THIS DRAWING IS SUBMITTED FOR APPROVAL ONLY
 BY *[Signature]*
 DATE 12-13-73
 CONTRACT # 42-580

TITLE	NO. OF SPINDLES SHOWN ON THIS SHEET
NEW RIVER MARINE CORPS STATION VMO HANGER FIRE PROTECTION SYSTEM CONTROL PANEL LAYOUT AND WIRING	42-580

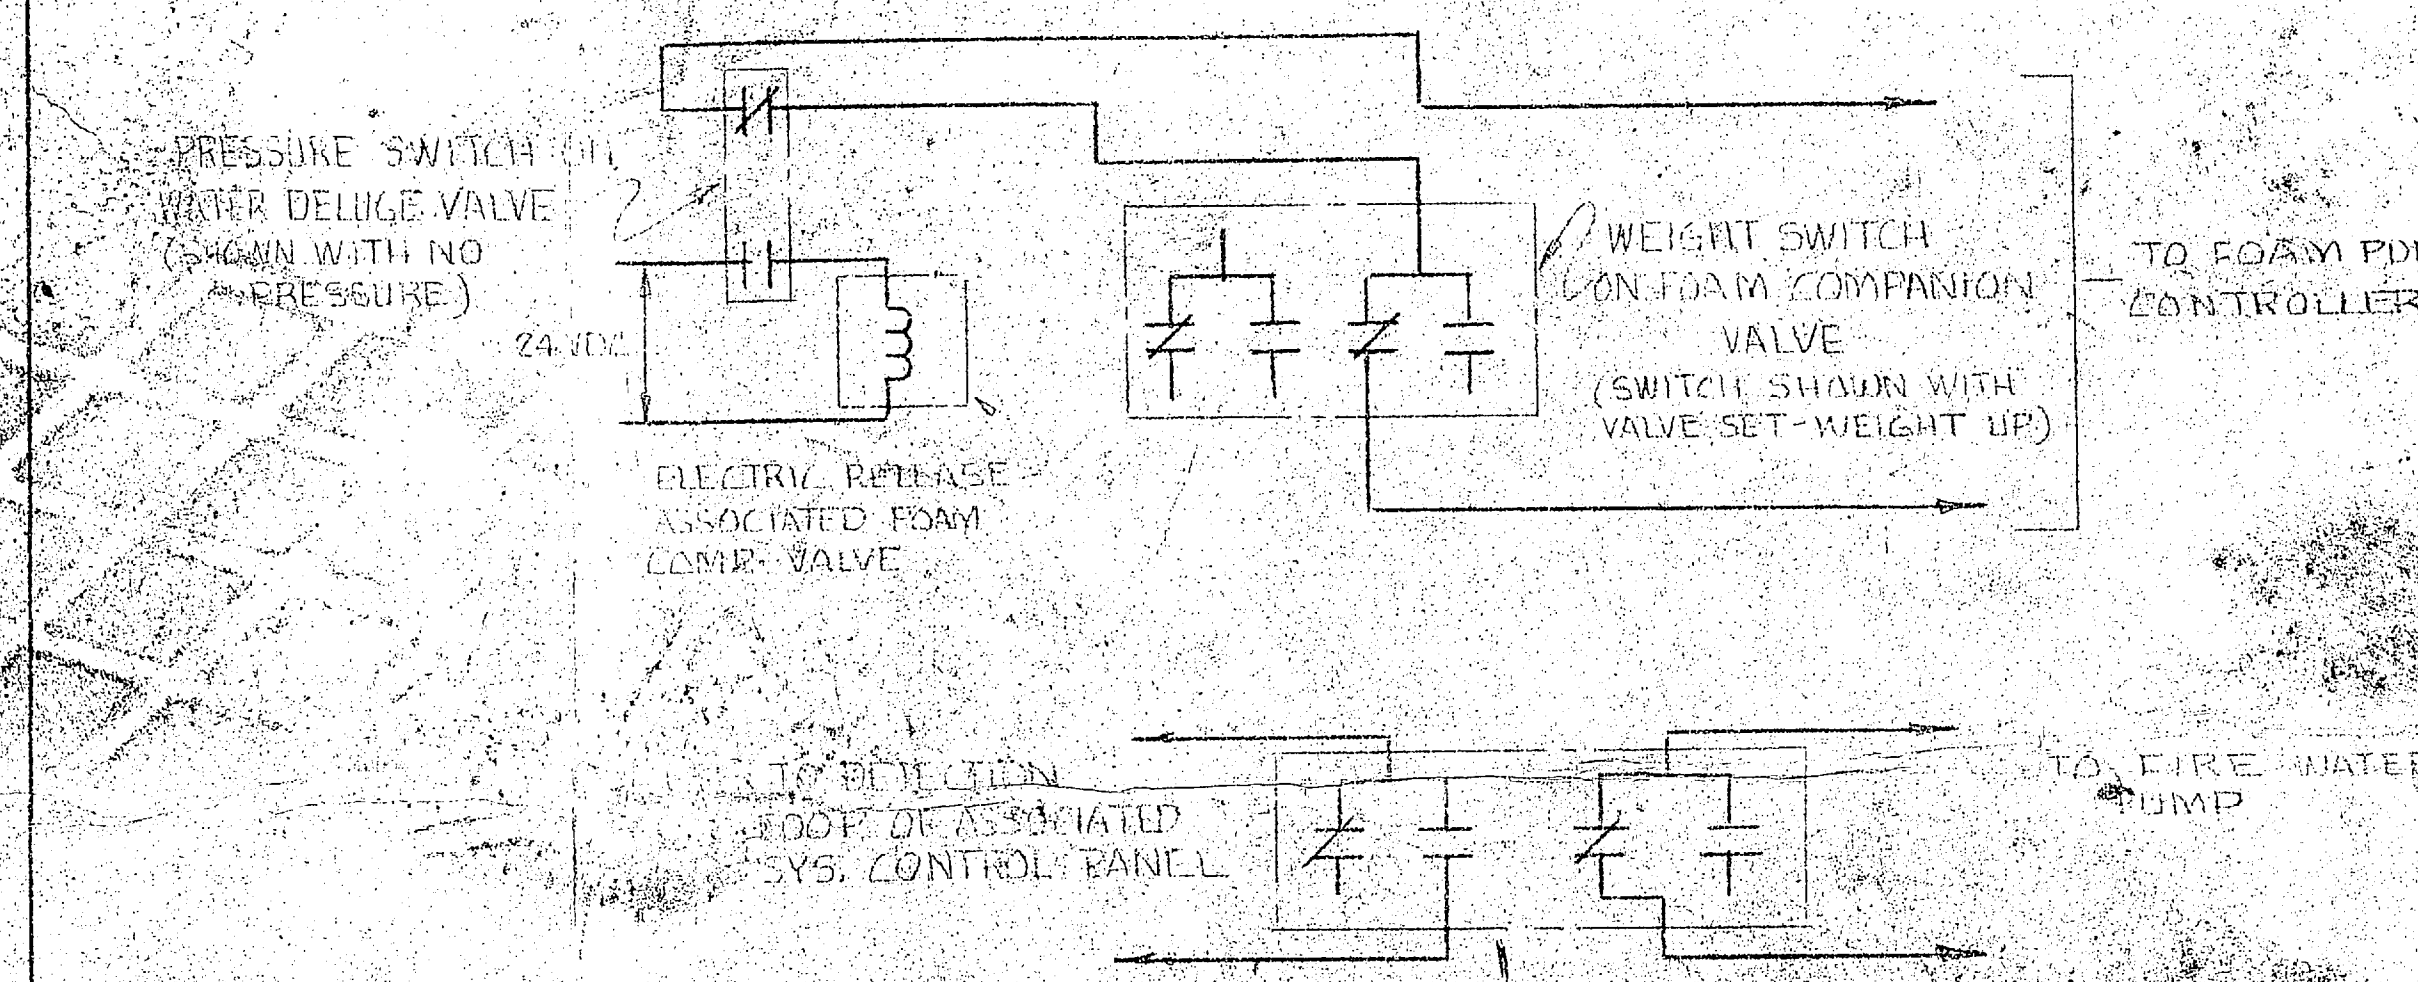
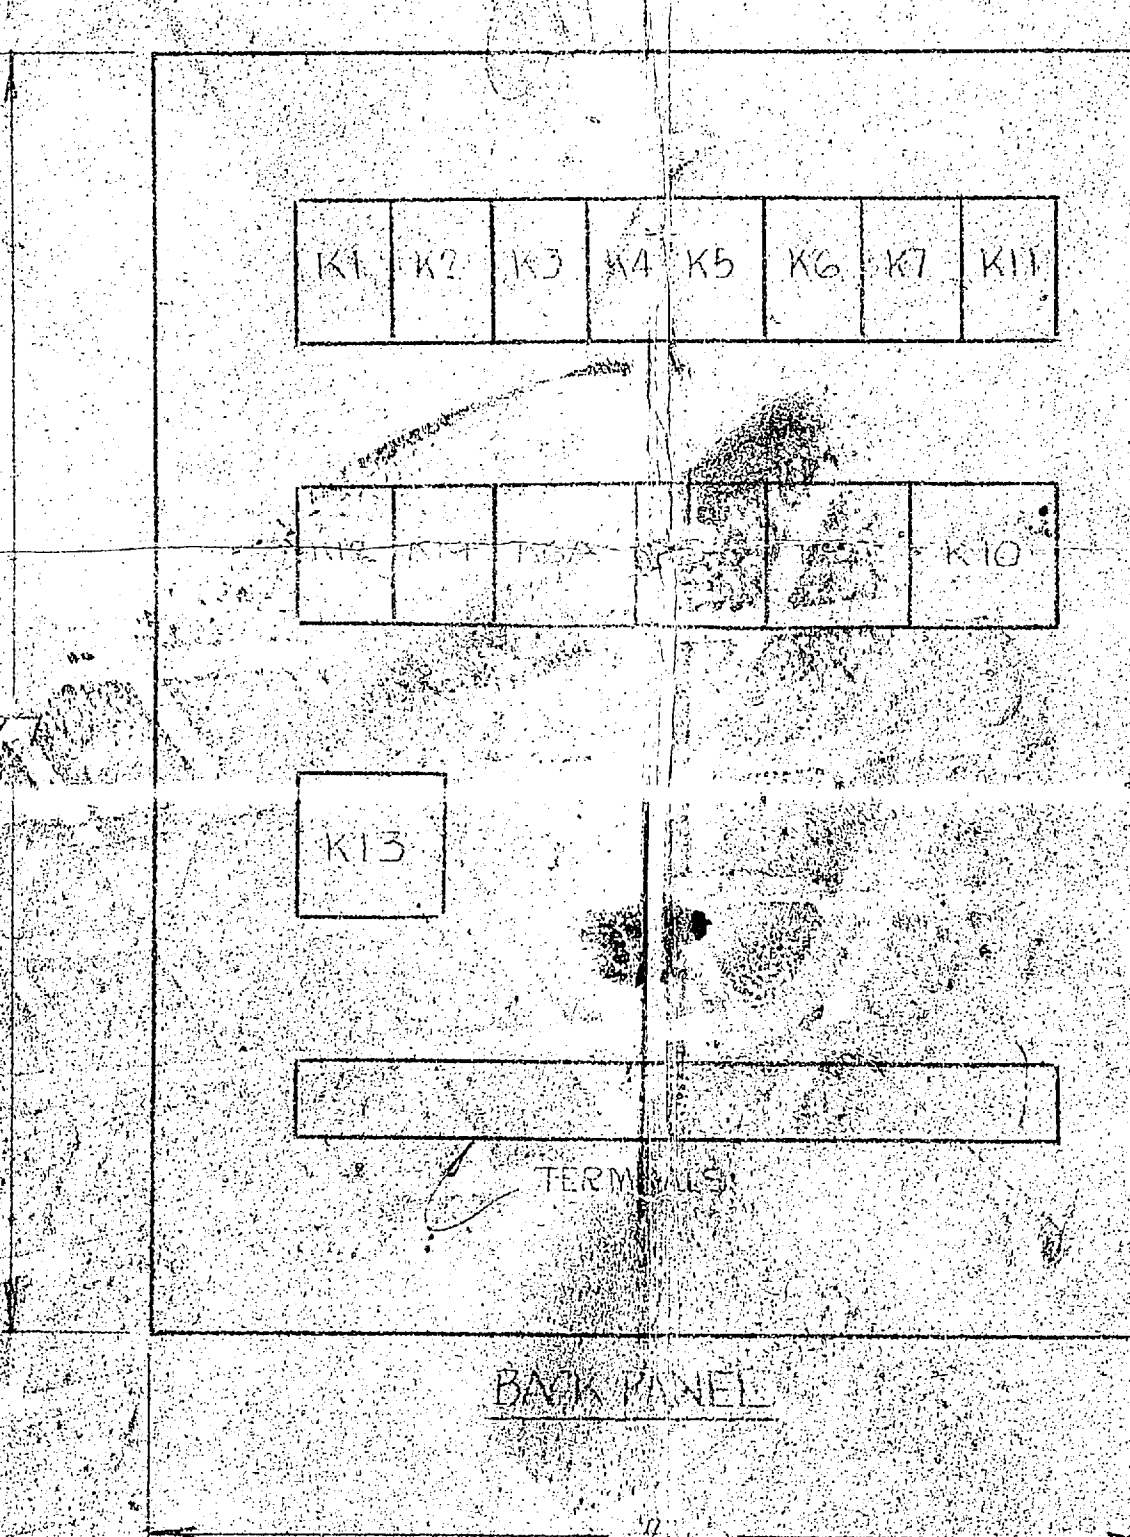
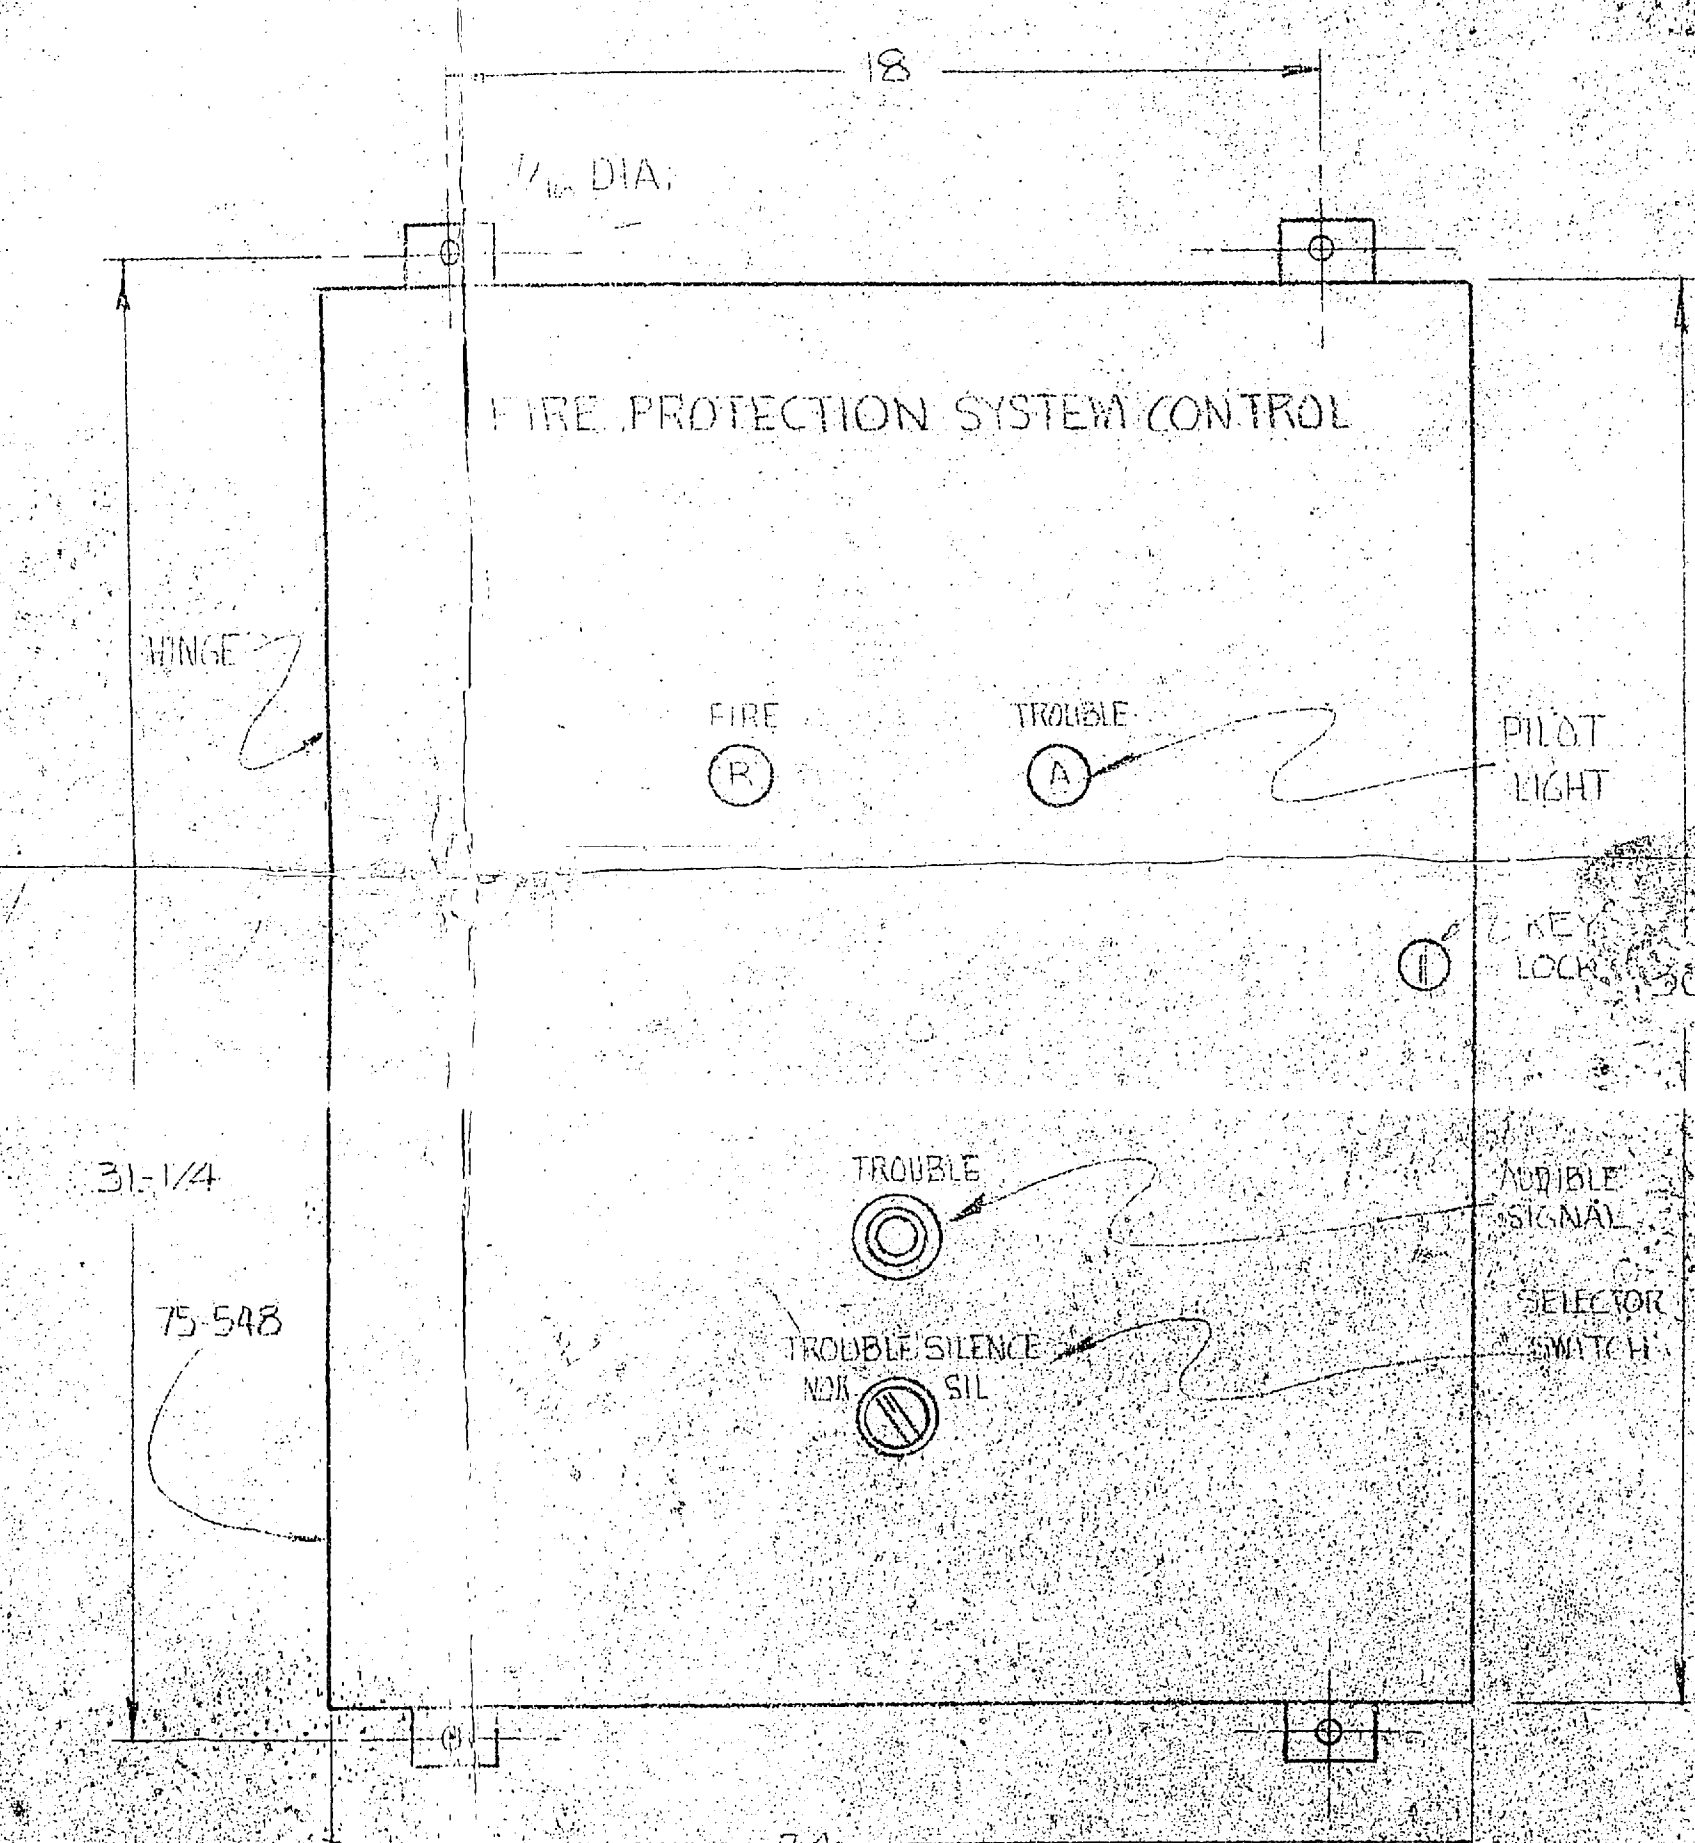
Wires #7 & #16 disconnected due to voltage drop on wire #9. This is caused by battery charger. Battery charger needs a separate power failure relays to charger one for the foam system control panel in mechanical room and one relay to use with this panel. Present battery charger has only one relay.
